Groundwater Transfer Review Summary Form

Transfer/PA # T- 13630

GW Reviewer Jen Woody Date Review Completed: 4/12/2021

Application: T-13630

Figure 2. Hydrograph

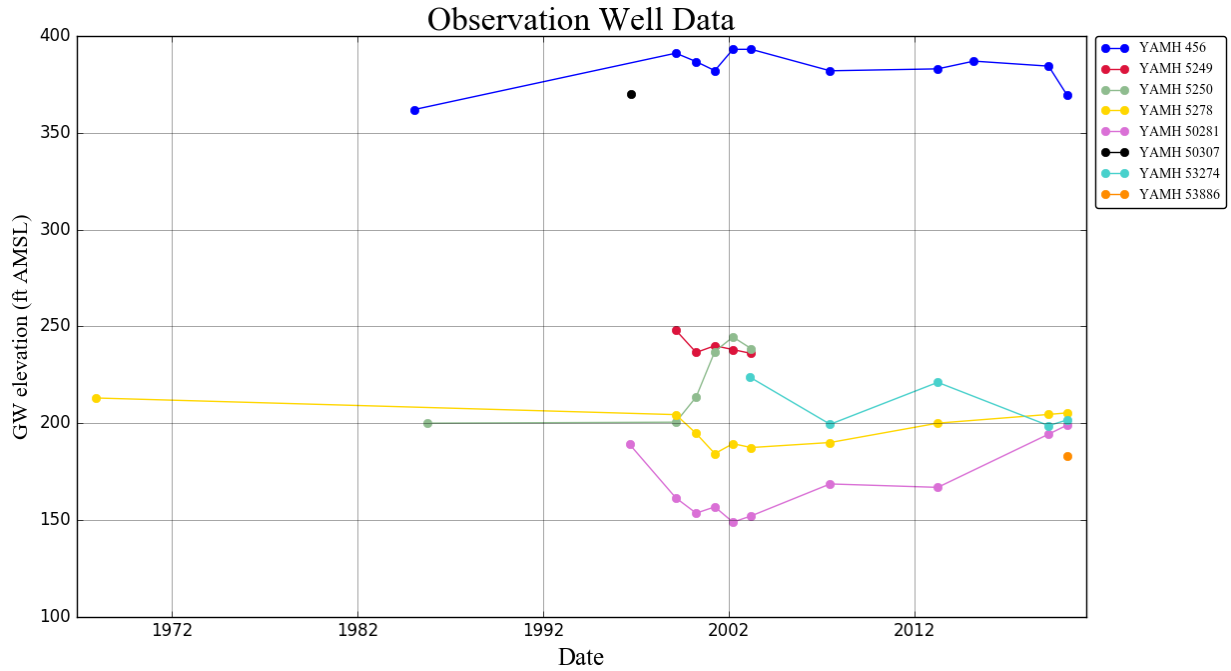
YAMH 456 and YAMH 50307 (wells 3 and 4) access one or more CRBG aquifers above 250' AMSL and have static water elevations above 350' AMSL (see Figure 2).

Water level data are reported for permit conditions at some of the subject wells. Taking the reported water levels at face value, there are two groups of wells. YAMH 456 and 50307 (wells 4 and 3) have water level elevations that are more than 100 feet higher than those at the rest of the subject wells. This indicates at least 2 distinct groundwater sources associated with the two current permits.

Figure 3. Cross-Sectional Diagram

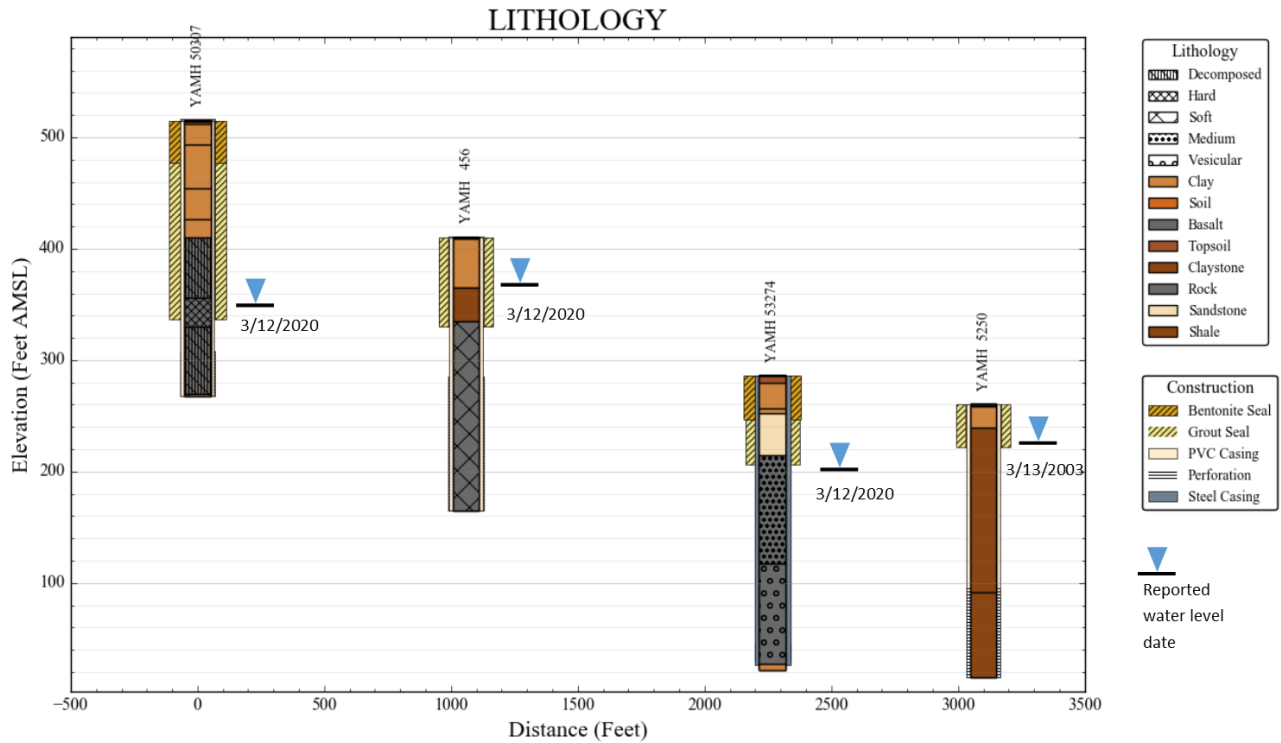
YAMH 50307 and 456 access a CRBG aquifer with a static water level elevation above approximately 350' feet amsl. All of the remaining wells involved in this permit amendment and the drain tiles access water in the marine sedimentary rocks or CRBG with a static water level below approximately 250' AMSL.
